Subject: RATTLE NOISE FROM REAR SPOILER WHEN CLOSING LIFTGATE	Bulletin No: 09-049/16
	Last Issued: 09/22/2016

Some vehicles may exhibit a rattle noise from the rear spoiler when closing the liftgate.

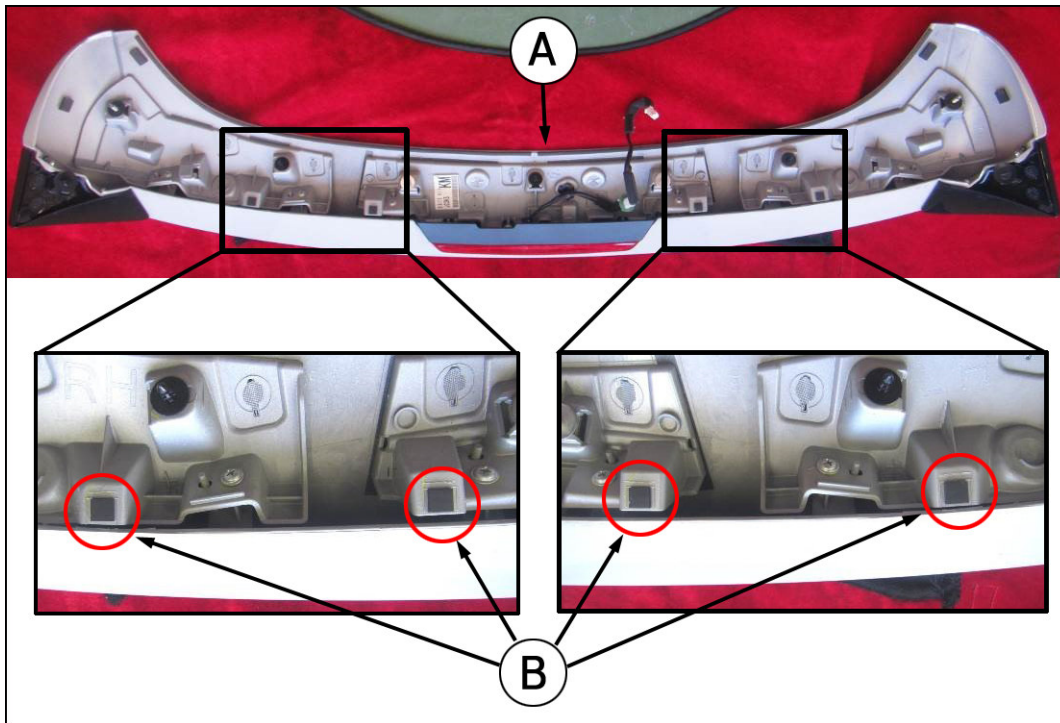
This may be caused by too much clearance between the rear spoiler and liftgate glass. The excessive clearance may cause the rear spoiler to rattle when closing the liftgate.

The rear spoiler protector (B) thickness has been increased at production to improve fit between rear spoiler and liftgate glass (C) to eliminate the noise when closing the liftgate.

3. Remove the protectors (B) (X4) from the rear spoiler (A) as shown. Clean the old protector adhesive surface using a genuine part cleaner.

4. Attach the new protectors (B) (X4) to the rear spoiler as shown above.
